ARCHITECTURAL REVIEW BOARD MEETING
CITY HALL, 385 SOUTH GOLIAD STREET, ROCKWALL, TEXAS
JULY 29, 2025 IN THE CITY COUNCIL CONFERENCE ROOM AT 5:00 PM

PROJECT COMMENTS

PROJECT NUMBER: SP2025-032
PROJECT NAME: Site Plan for 855 Whitmore Drive
SITE ADDRESS/LOCATIONS: 855 WHITMORE DR

3/16" = 1' 0"

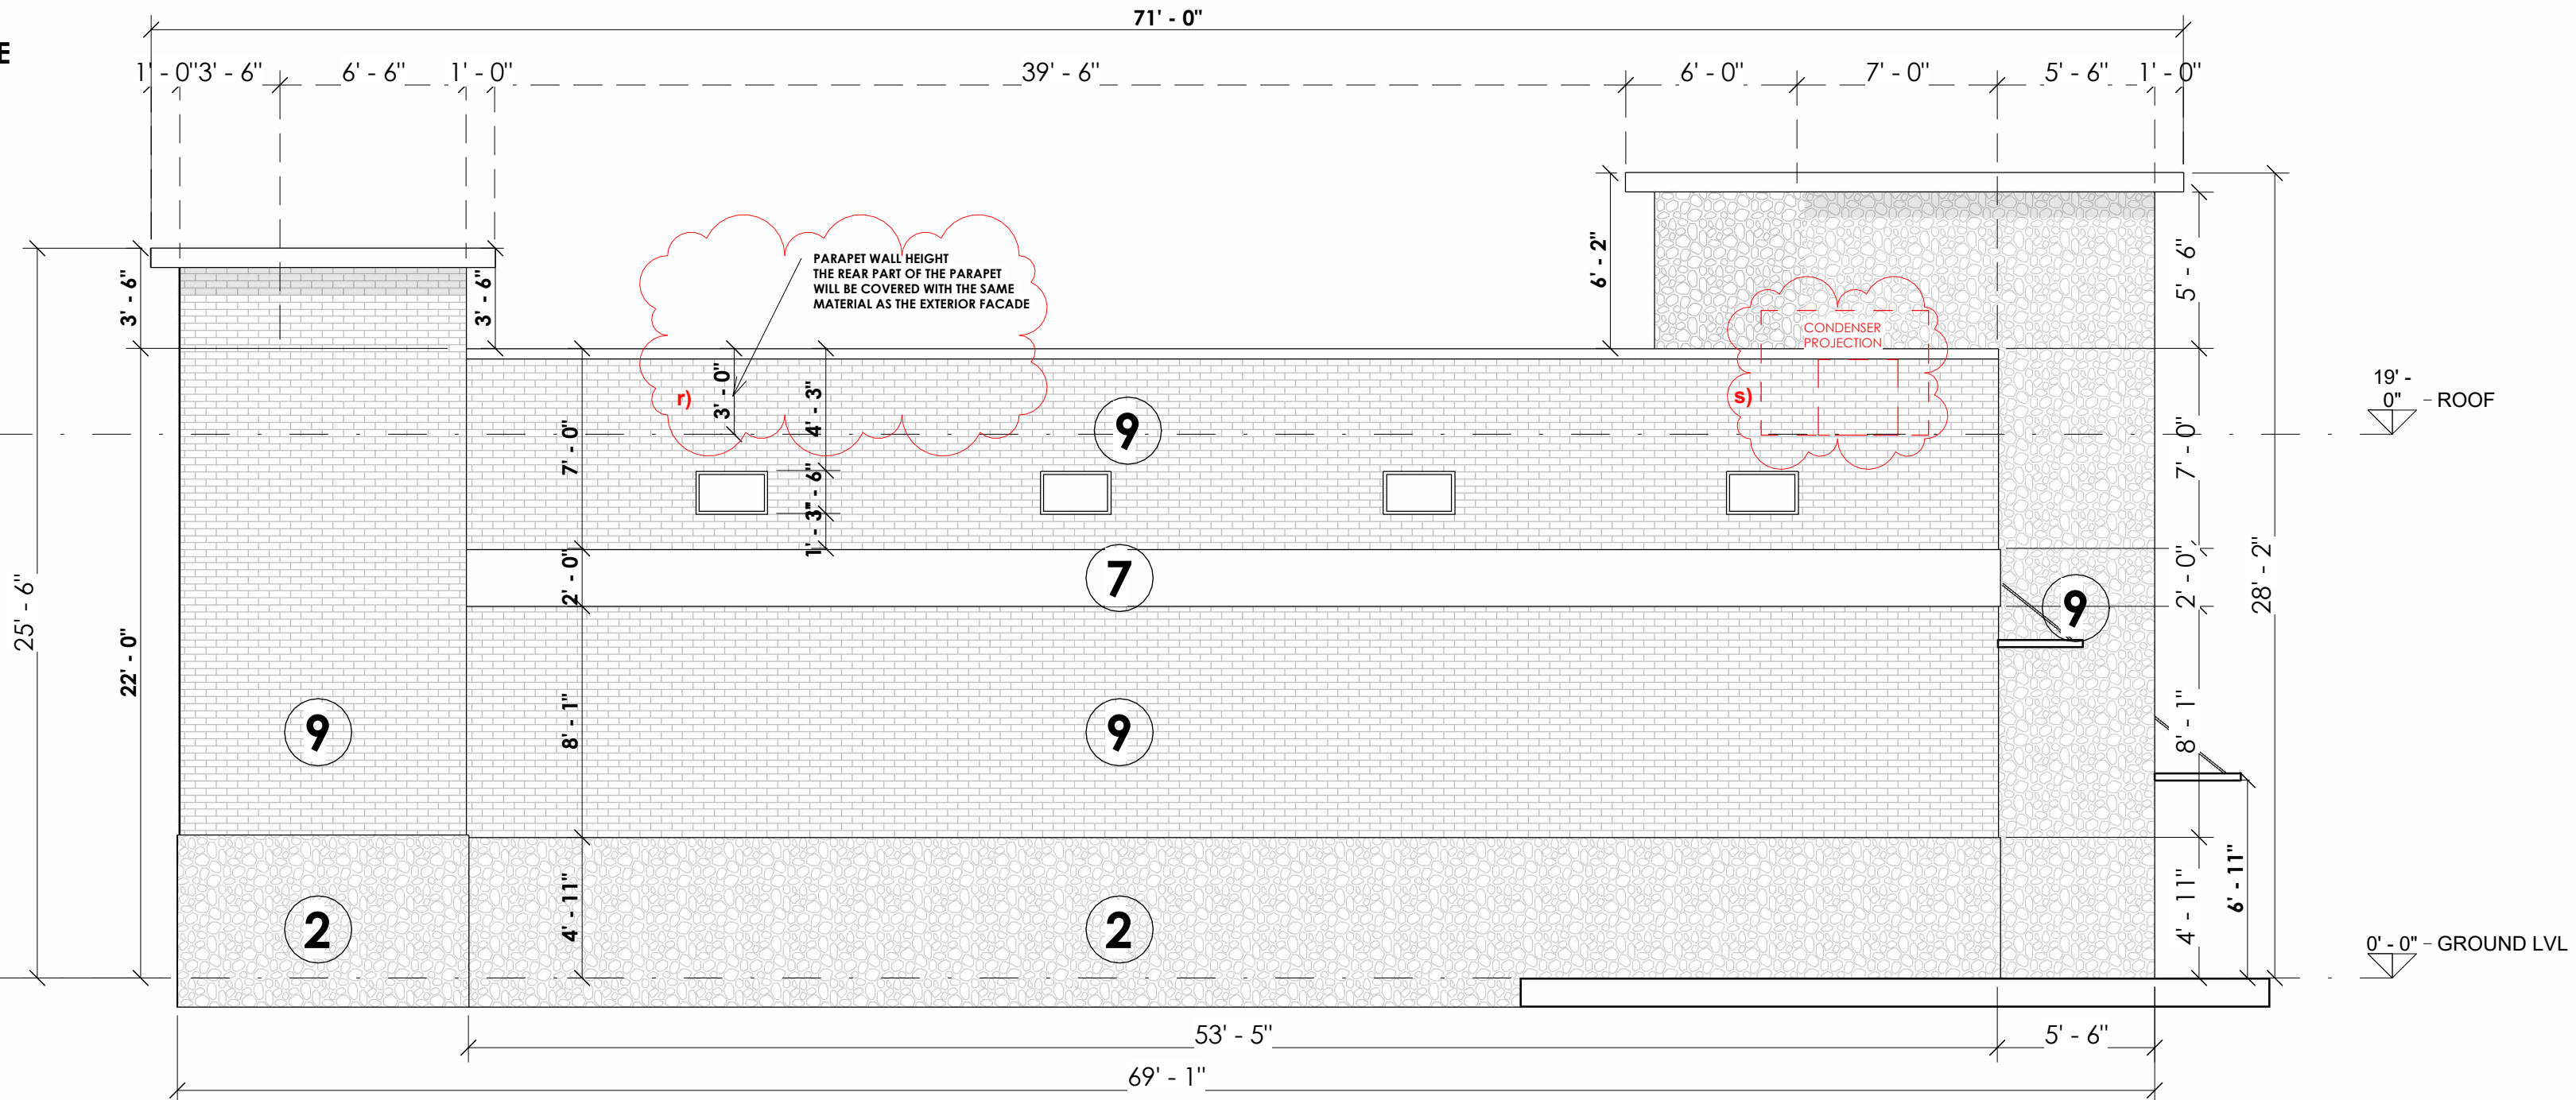
M.10 Building Elevations

- (1) Please delineate and label the scuppers and downspouts. (Subsection 05.01. of Article 05, UDC)
- (2) All RTUs must be fully screened by the parapet. In this case, the RTUs extend above the parapet wall. (Subsection 01.05. C, of Article 05, UDC)

SITE PHOTOMETRICS PLAN

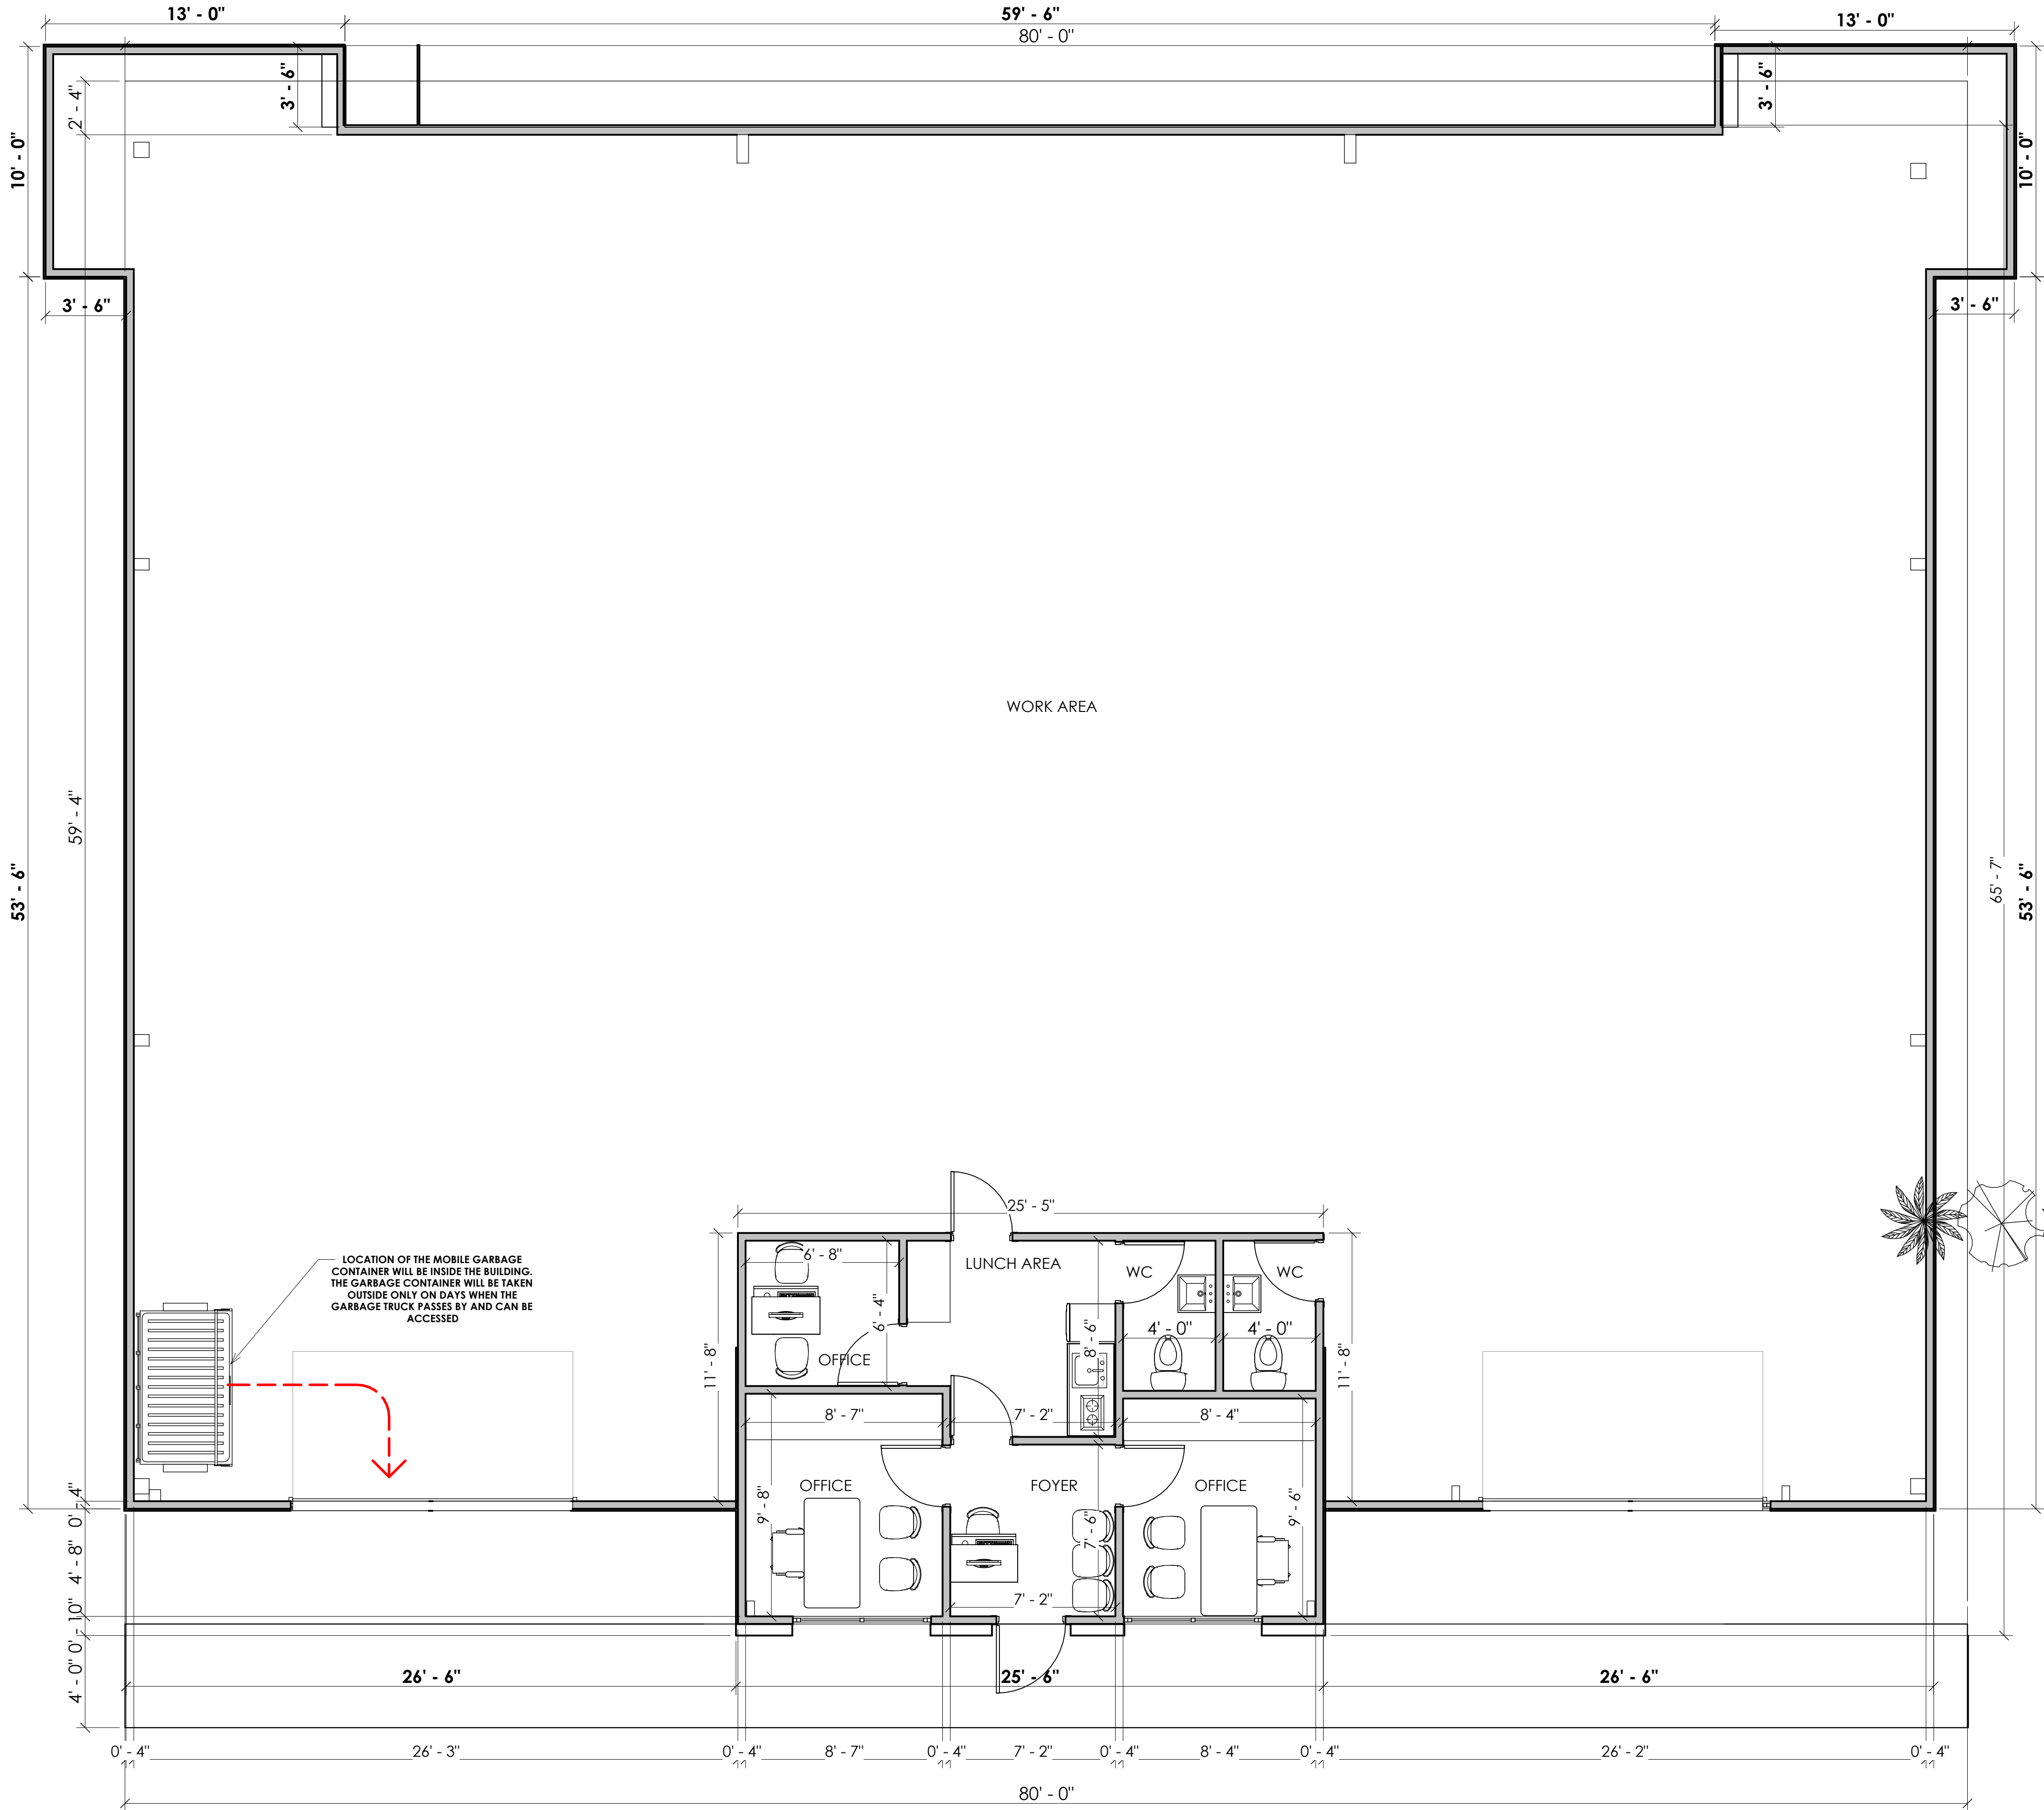
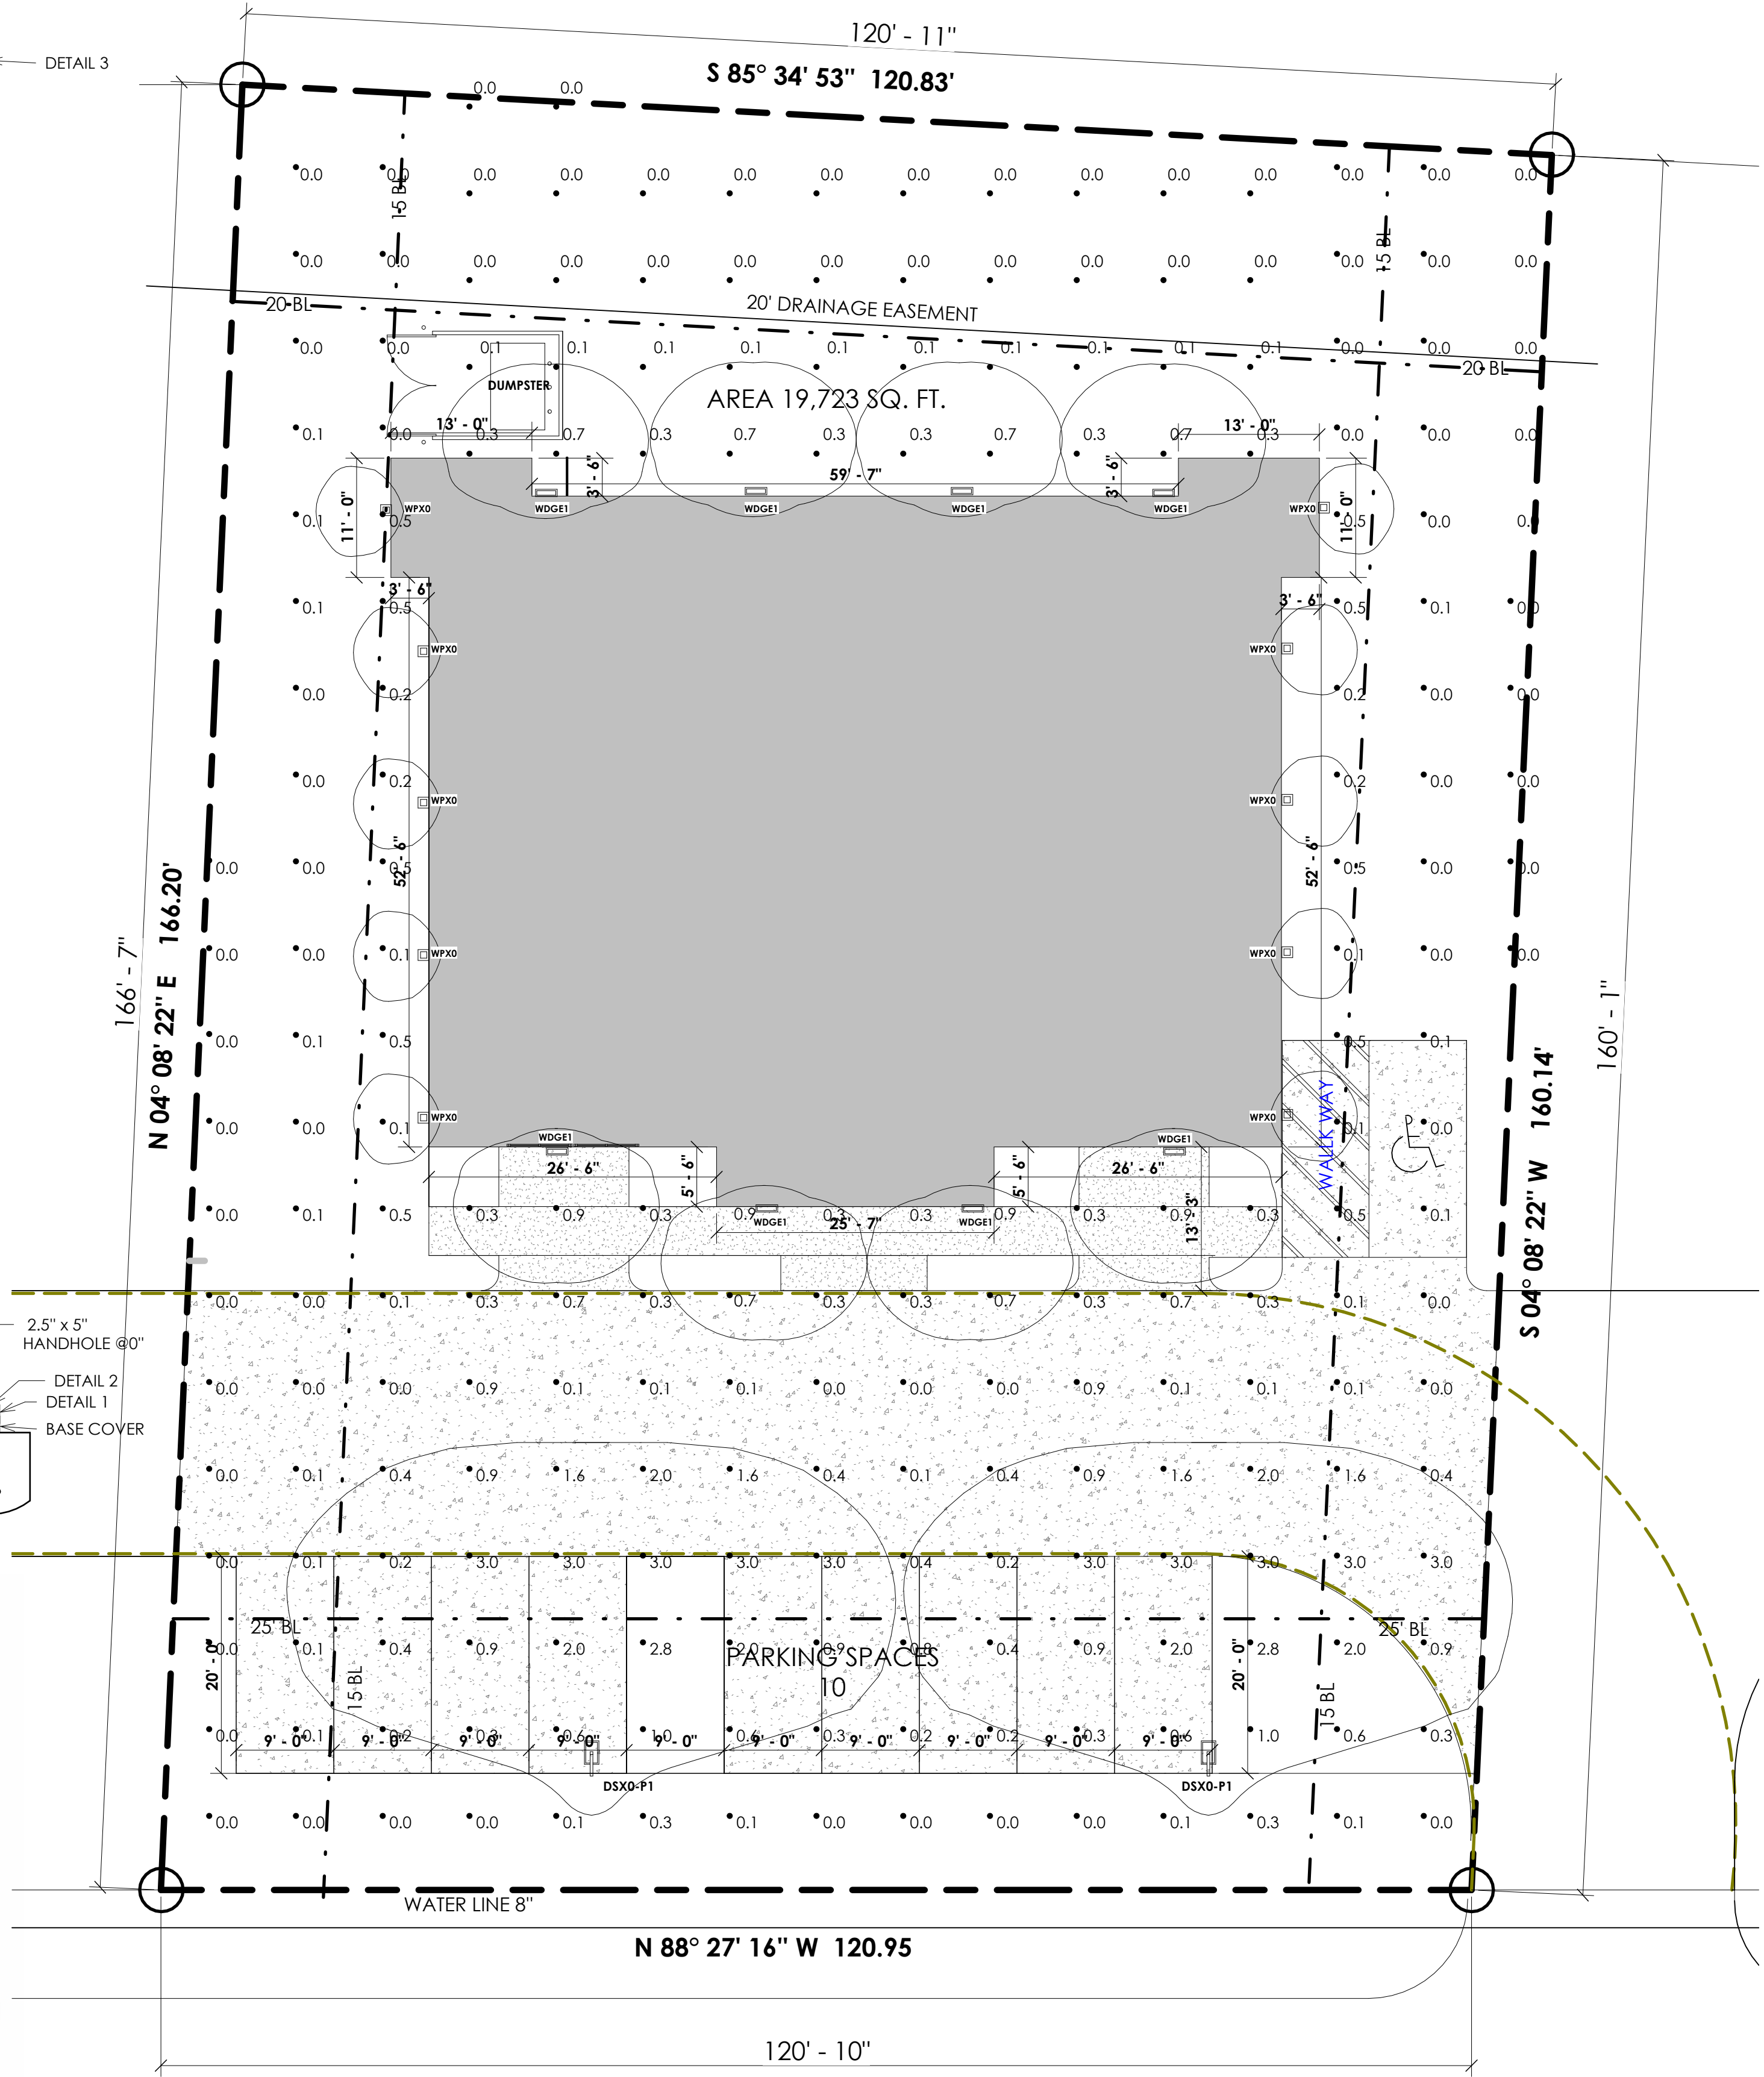
M.9 Photometric Plan

- (1) Provide the same site data information required in Section 2.1 Site Plan: Miscellaneous and Density and Dimensional Requirements of this checklist. (See Sec. 2.1 of the checklist)
- (2) Light levels shall not be greater than 0.2 FC at all property lines. Please provide the light levels at the property line. (Subsection 03.03, of Article 07, UDC)
- (3) All light fixtures shall be fully shielded and oriented downward. (Subsection 03.03, of Article 07, UDC)
